Subject: Juniper Ridge Landfill Expansion Application, MEDEP #S-020700-WD-BI-N Follow-up to Department Staff's Responses to the March 4, 2016 Submittal on Staff's Review Comments as Presented in the Department's April 5, 2016 Letter

## EXHIBIT D

### **BGS AND NEWSME'S RESPONSE TO MEDEP'S APRIL 1, 2016 TECHNICAL MEMORANDA**

**PW-08-02**  
50-HOUR PUMP TEST  
MARCH 17, 2009 TO MARCH 19, 2009  
AVERAGE 73 gpm  
59.38 FEET OF DRAWDOWN

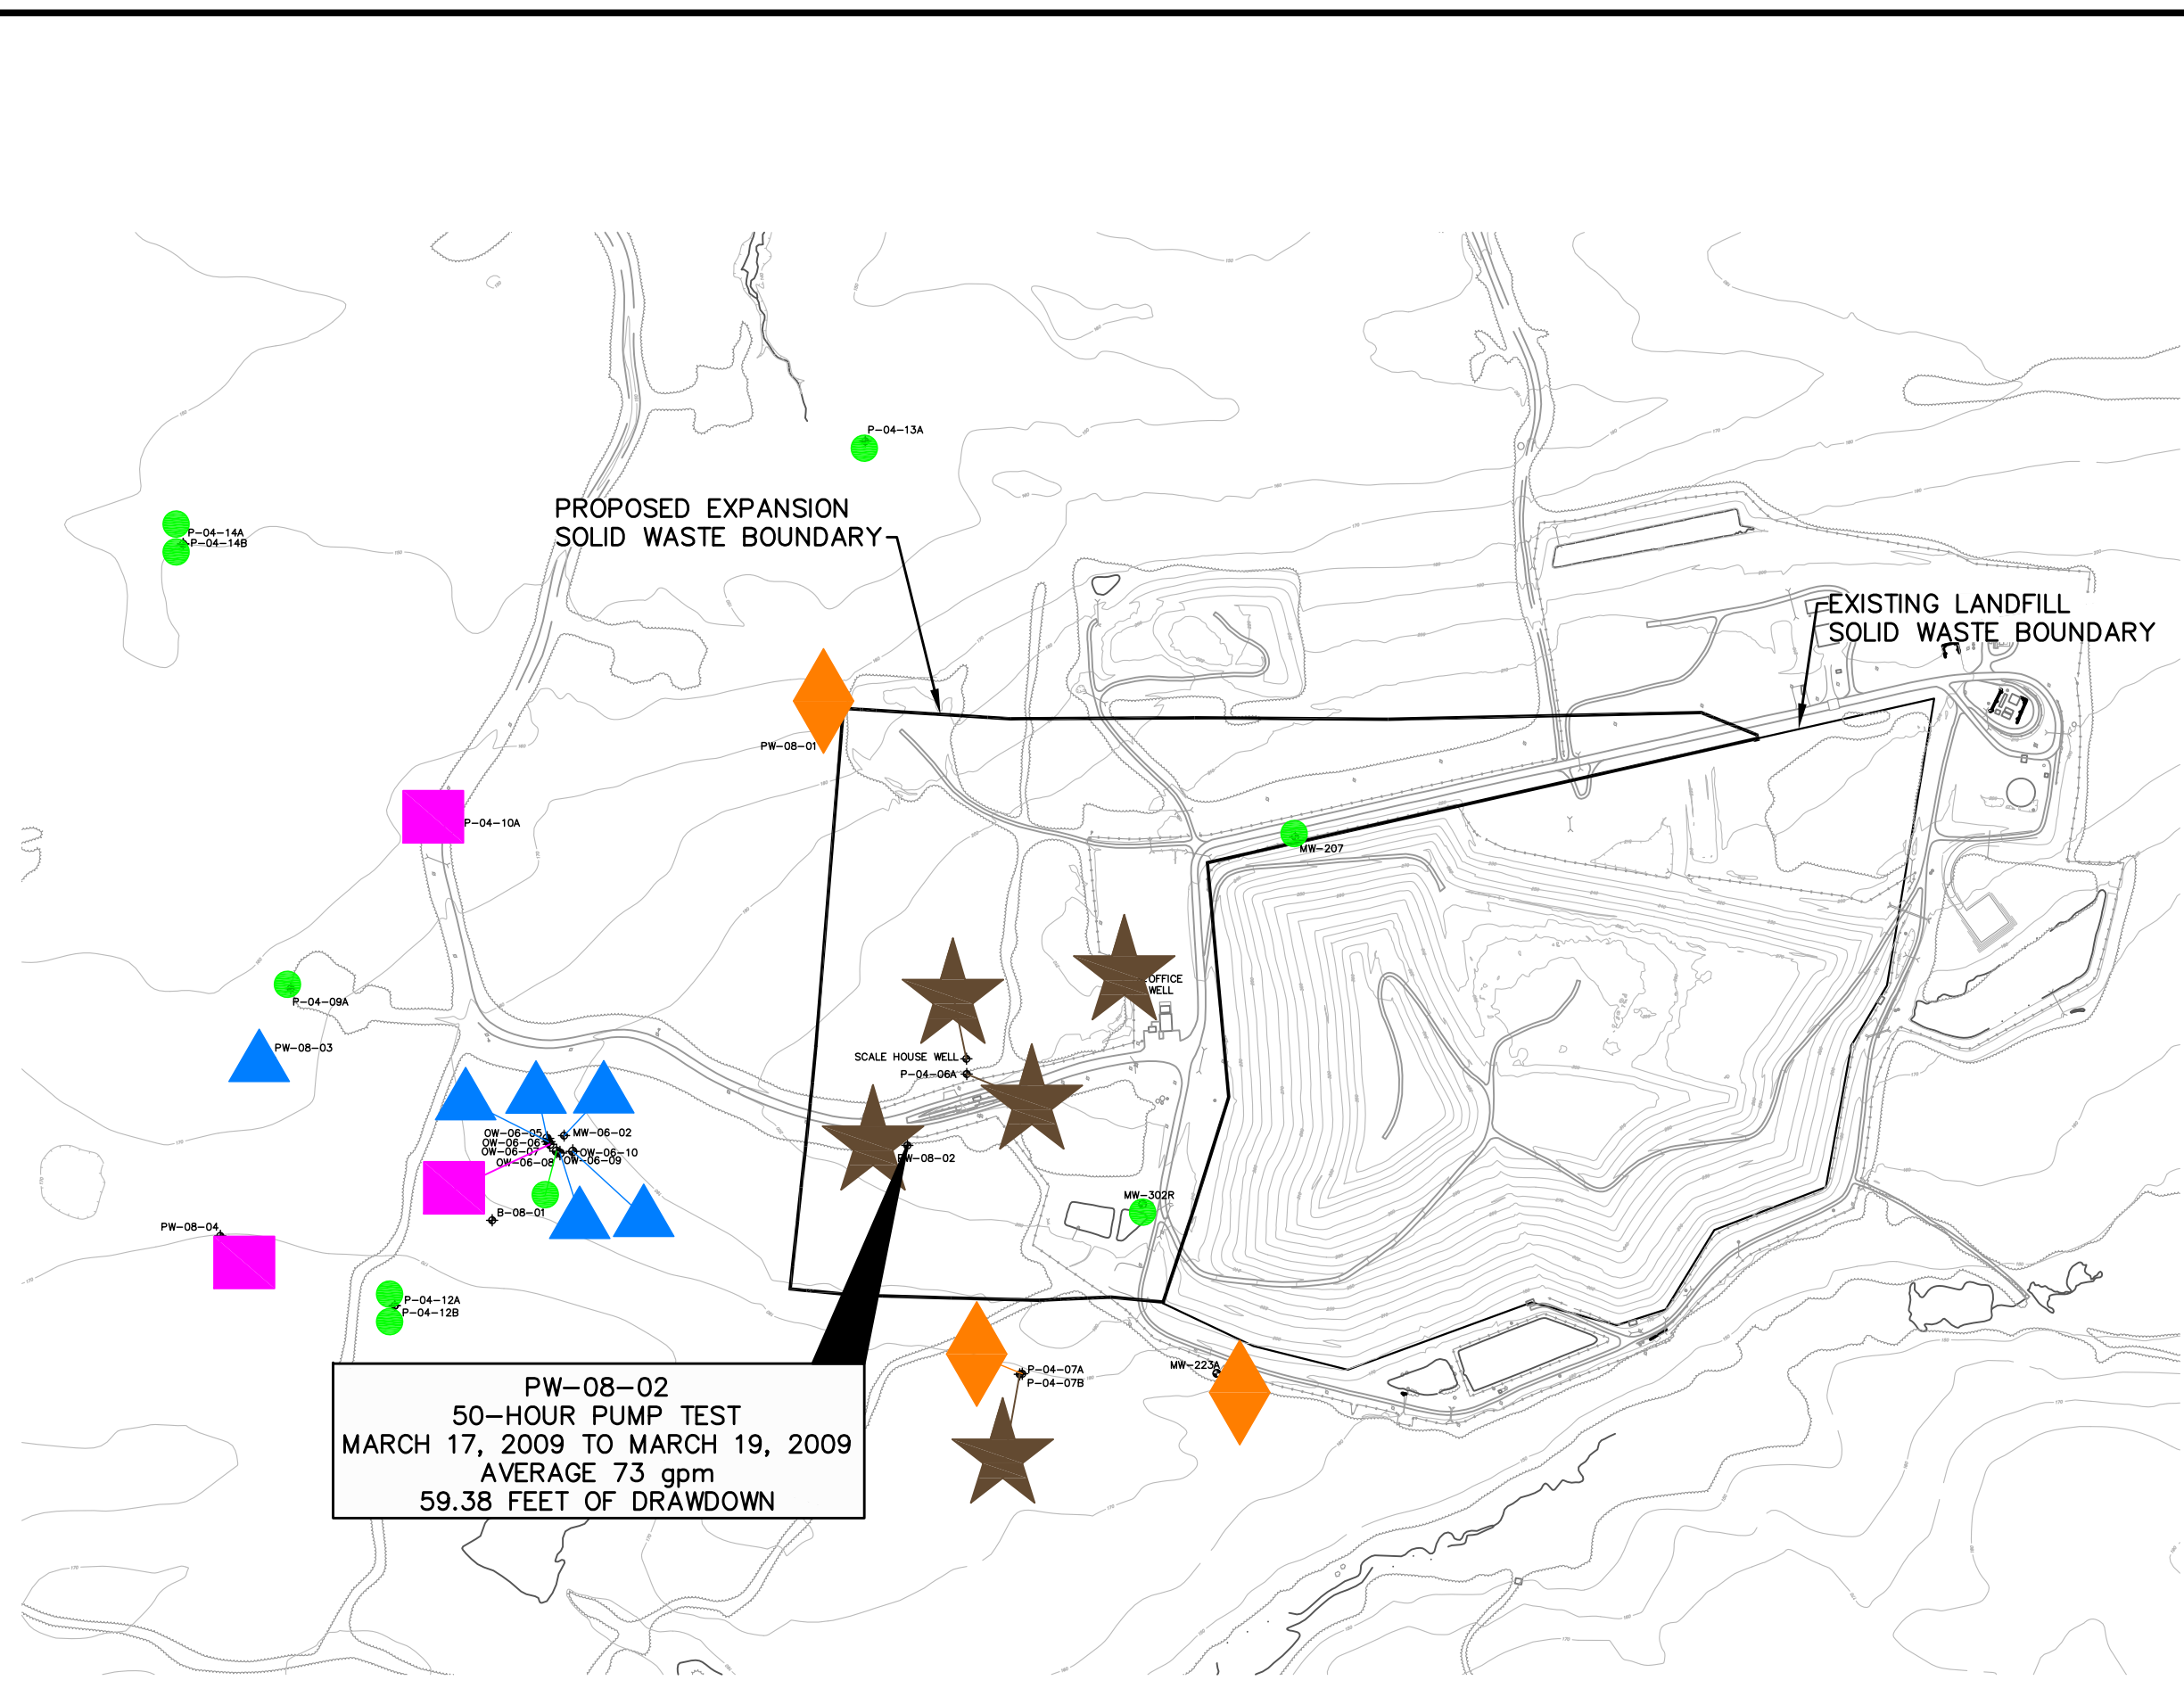
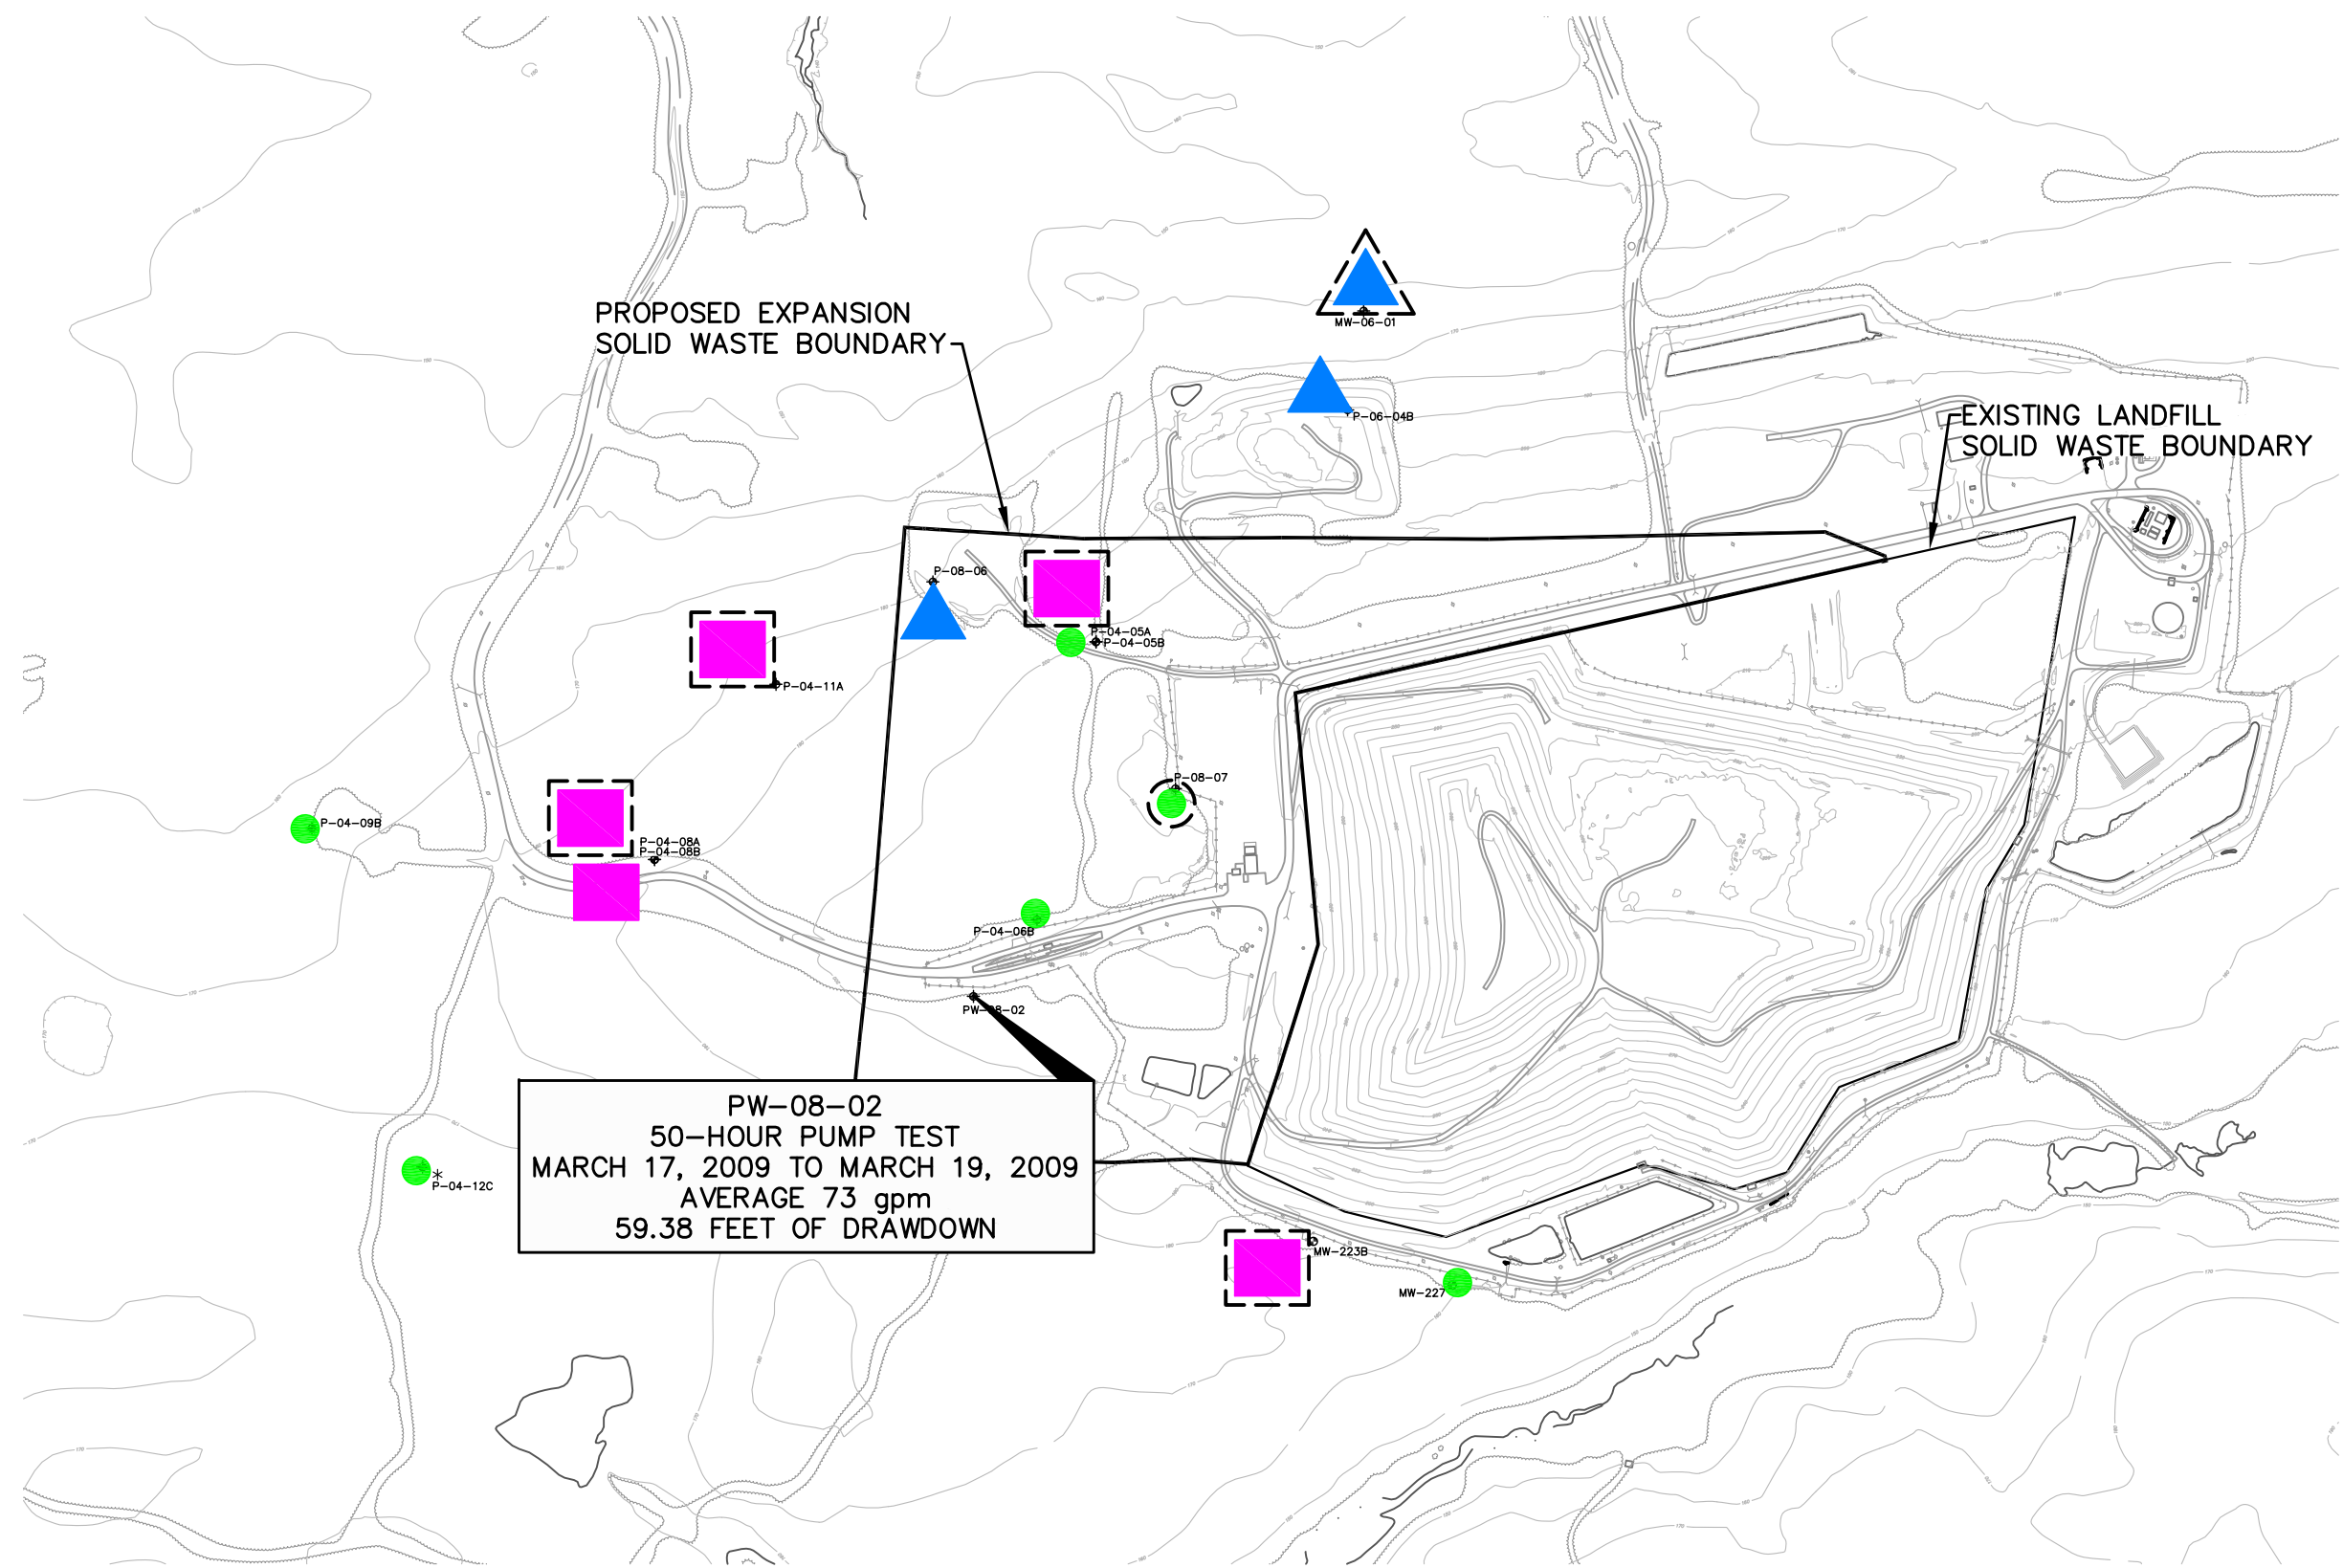
**MEDEP Follow-on Response: My original comment included a request for figures to illustrate the observed drawdowns in monitoring wells screened in the till. JRL's**

response did not include the requested figures. I continue to assert that a graphic depiction of locations where the till is hydraulically connected to the underlying bedrock is important and may assist in locating wells for long term monitoring and extraction wells in the unlikely event a significant leachate release were to occur.

**MEDEP – Follow-on Response:** JRL's response to my comments about Figures U-14 and U-15 do not adequately address my comments. Additional figures are needed to properly illustrate the data collected during each of the five pumping tests. To further enhance the results of the pumping test data, it is necessary to include all of the drawdown data obtained during each test. Again, I contend it is important to differentiate between bedrock and till wells. As an example, the figure (Figure U-14) illustrating the 26.5 hour pumping test performed on PW-08-04, uses graduated symbols to depict the range of observed drawdowns for only 20 of the 53 wells where water levels were observed. There are also apparent inaccuracies on the existing figures. The text on page 26 states six wells (5 bedrock and 1 till) experienced between 0.1 and 1.0 foot of drawdown although Figure U-14 only depicts three wells in this range. The figure (Figure U-15) depicting the drawdowns observed during the long-term pumping tests at PW-08-01 and PW-08-02 also requires revisions as only a fraction of the drawdown data is depicted on this figure. Although JRL collected drawdown data for 53 wells during the tests, Figure U-15 only depicts data for 21 wells.

To address these comments, I recommend JRL display all of the drawdown data for each pumping test on appropriately scaled figures. I also ask JRL to augment the drawdown data included in Appendix M with a table summarizing the total drawdown observed in all wells during each of the pumping tests. This table would include those wells instrumented with pressure traducers and those where manual water levels were made. I am certain JRL has previously compiled this data to complete the pumping tests analyses. I also request that JRL also provide the Department with an electronic copy of the spreadsheet.

Applicants' Response: Included in Attachment SME-D3 are ten figures augmenting Figures U-14 and U-15 included in Appendix U of Volume II of the Application. These figures show monitoring wells and piezometers where drawdowns were measured during the pumping tests. For each pumping test two figures, one showing the drawdown in the bedrock, and one showing the drawdown in the till, have been prepared. On the figures showing the drawdowns in the till the locations where the instrument screen is located within five feet of the bedrock surface are identified.

Applicants' Response: See previous response to the comment regarding Appendix U, Pg 25, 5.0 Pump Test Proof of Bedrock Interconnectivity. The augmented U-14 and U-15 figures are contained in Attachment SME-D3.
